Agenda Item 3
McKinley Road Redevelopment – Final Phase
Demolition and New Construction

STAFF REPORT AND RECOMMENDATION

TO:	Chairman Grieve and members of the Historic Preservation Commission
DATE:	July 12, 2021
FROM:	Catherine Czerniak, Director of Community Development Jen Baehr, Assistant Planner
SUBJECT:	McKinley Road Redevelopment Phase Three – Demolition and New Condominium Building

Roof Plan

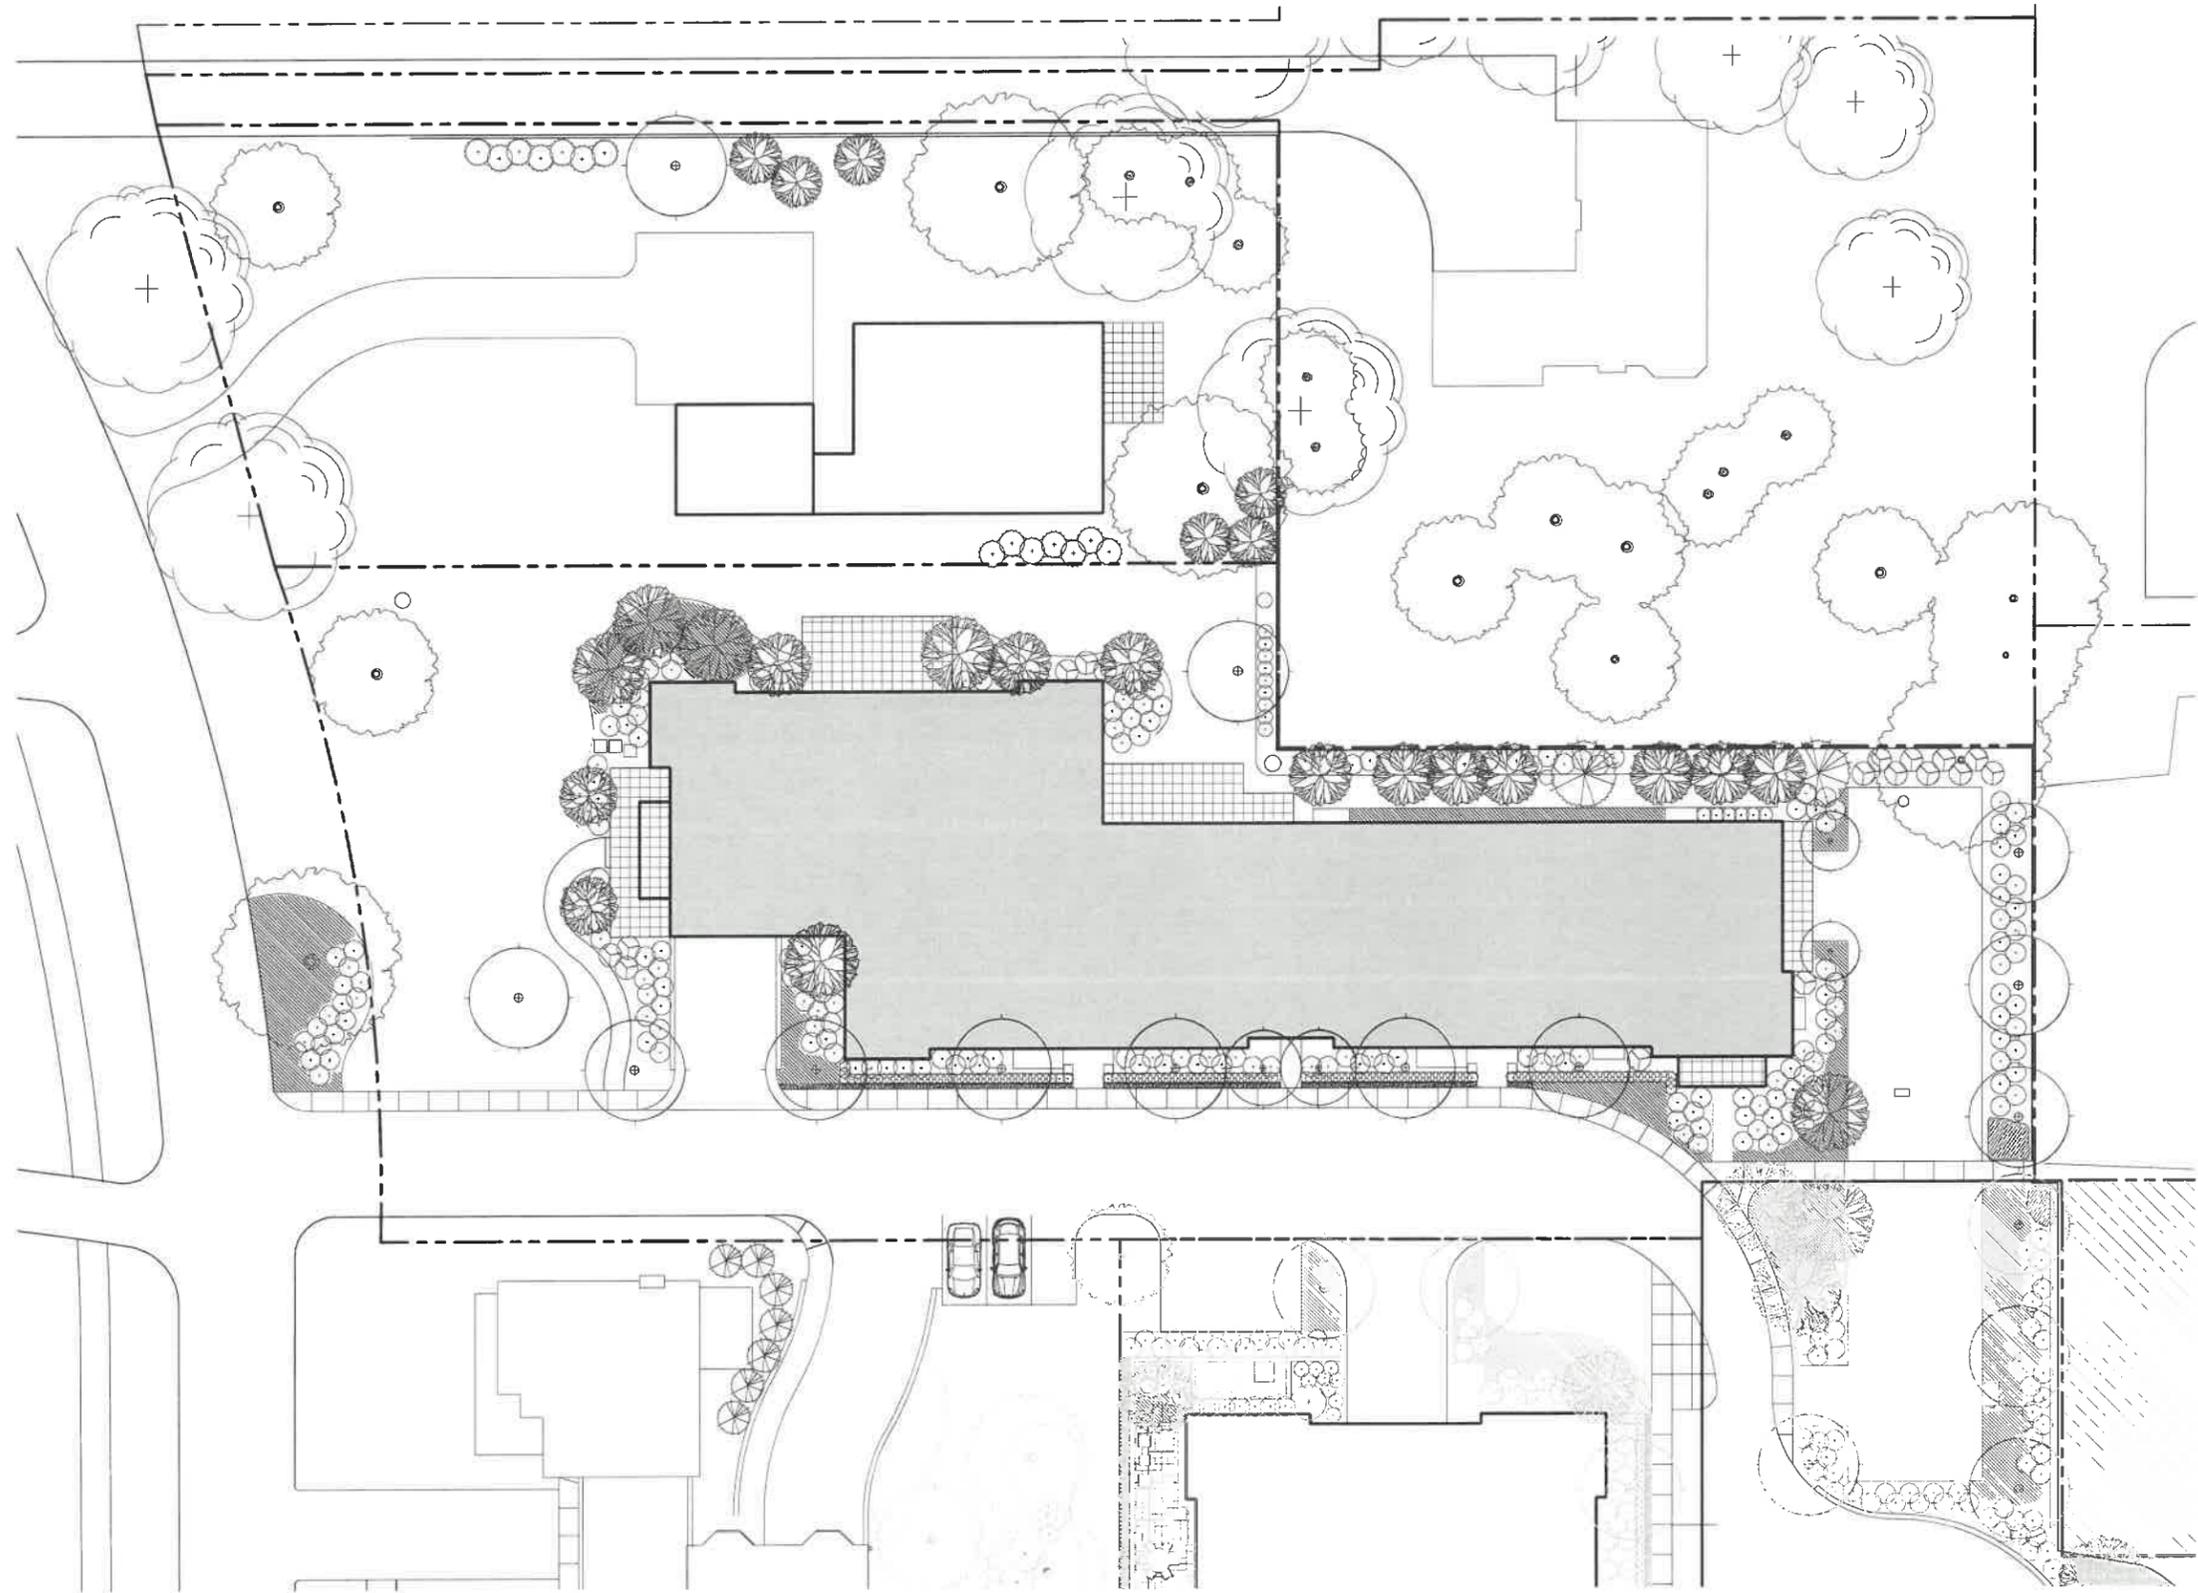
- Provide detail on the location and size of the active use areas on the roof.
- Provide detail on the height of the roof, the parapet wall, elevator over run and the stair enclosure, also referred to as a penthouse. (To clarify, there is not living space in the penthouse, only access to the stairway.)
- Consult the City Attorney on the process for re-approving the demolition of the residence on the 373 E. Westminster property and the timing for consideration of the second replacement structure, a new residence on the remaining portion of the 373 E. Westminster property. (A memorandum from the City Attorney is included in the Commission’s packet. Although attorney communications are often confidential, because questions about the demolition and timing for review of a new residence were raised by members of the public, the opinion is included as part of the packet.)

The hard surface seating areas and planted areas have been delineated on the plan. These areas and penthouse locations have been dimensioned and located Above the hard surface areas trellis for shading will be available for each owner option. The enclosed space on the structures are for light to stair access to the unit and for the private use of each individual unit.

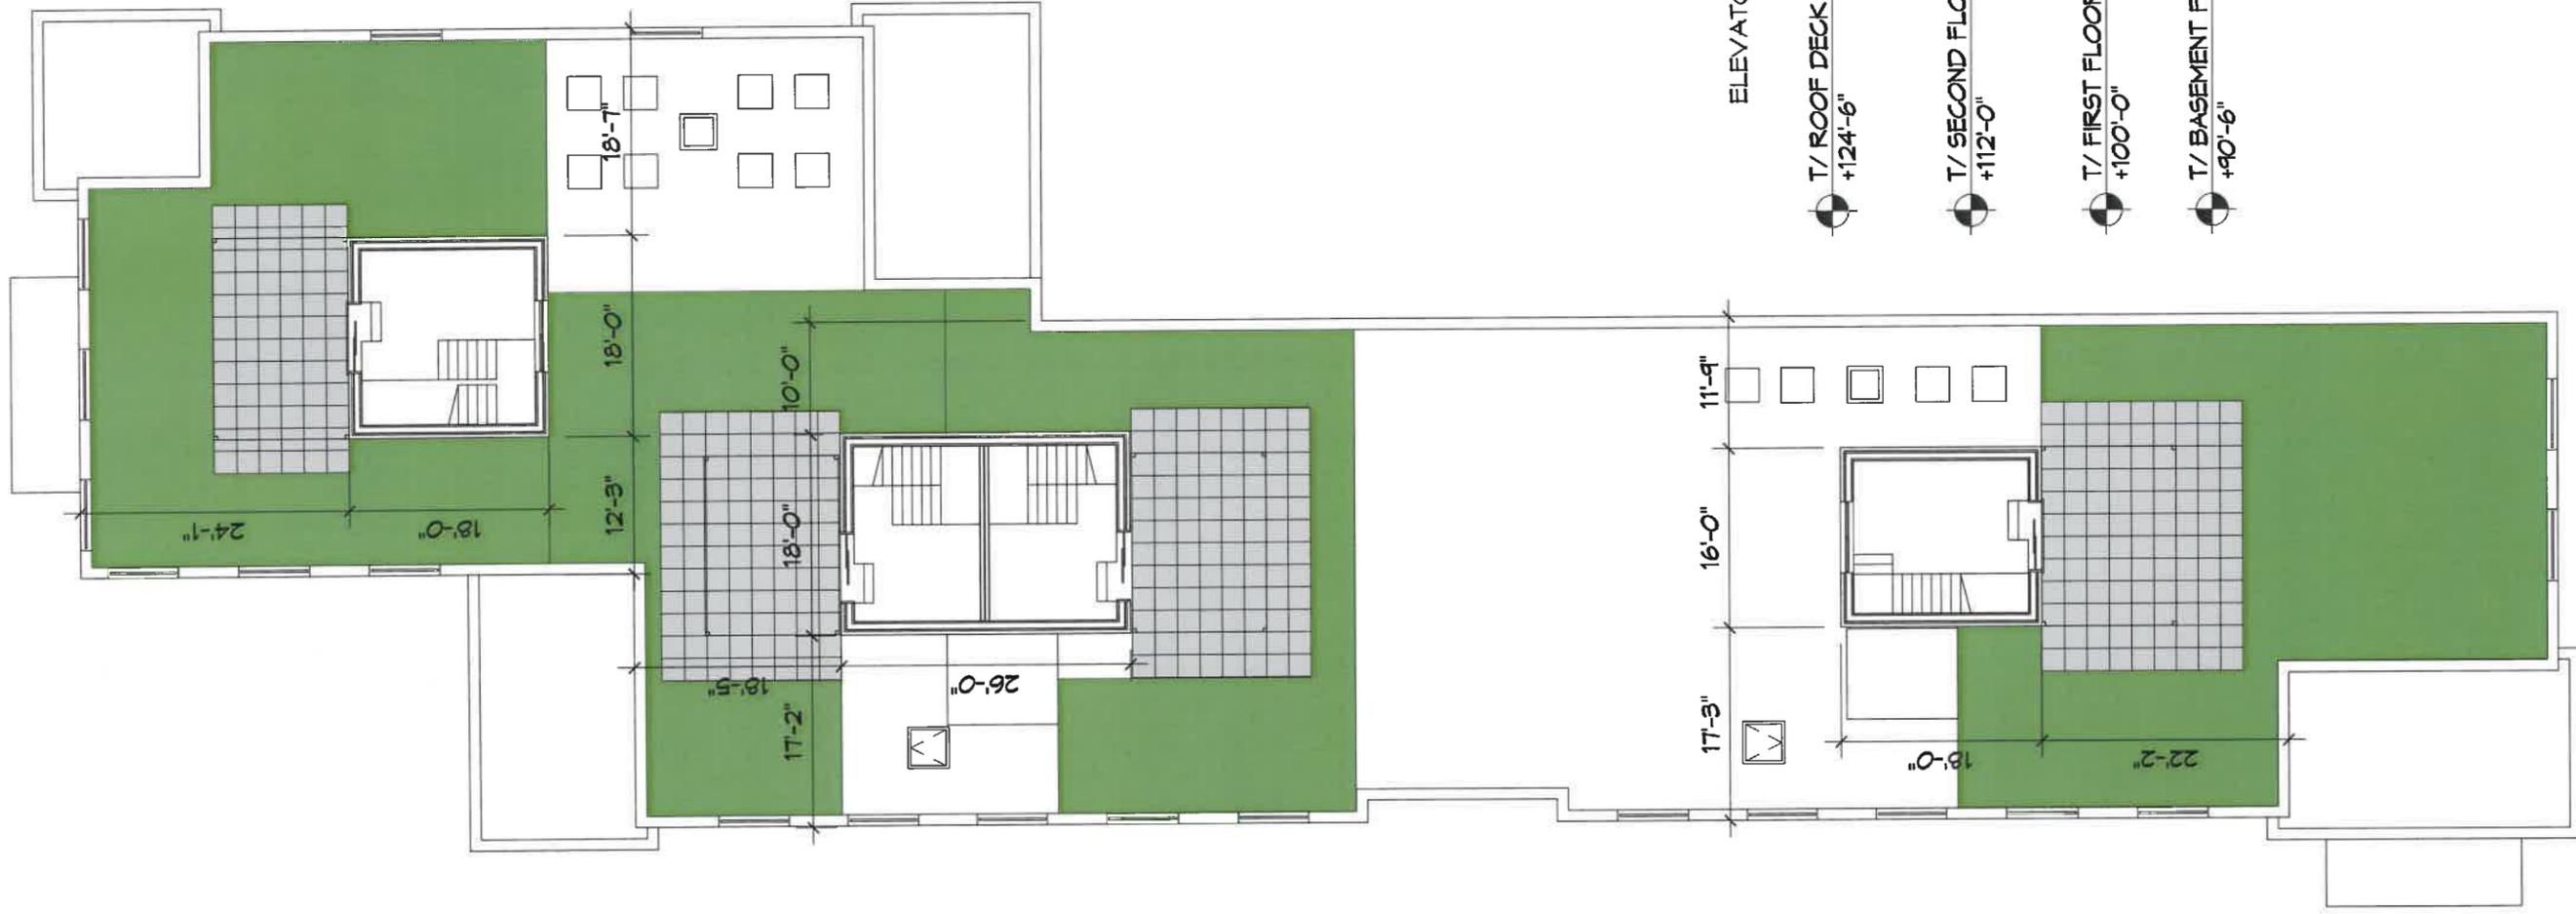
ELIMINATION OF STONE HEAD @ WINDOW REPLACE WITH BRICK SOLDIER COURSE

REMOVE FRENCH DOORS @ GRADE EXCEPT FOR STAIR EGRESS

ELIMINATE SCREEN PORCH & REPLACE WITH SMALLER ENTRY PORCH

CHANGED STONE CORNICE TO
BRICK SO NOT TO CONTRAST

ELIMINATION OF STONE HEAD
@ WINDOW REPLACE WITH
BRICK SOLDIER COURSE

ELIMINATE 18 WINDOWS
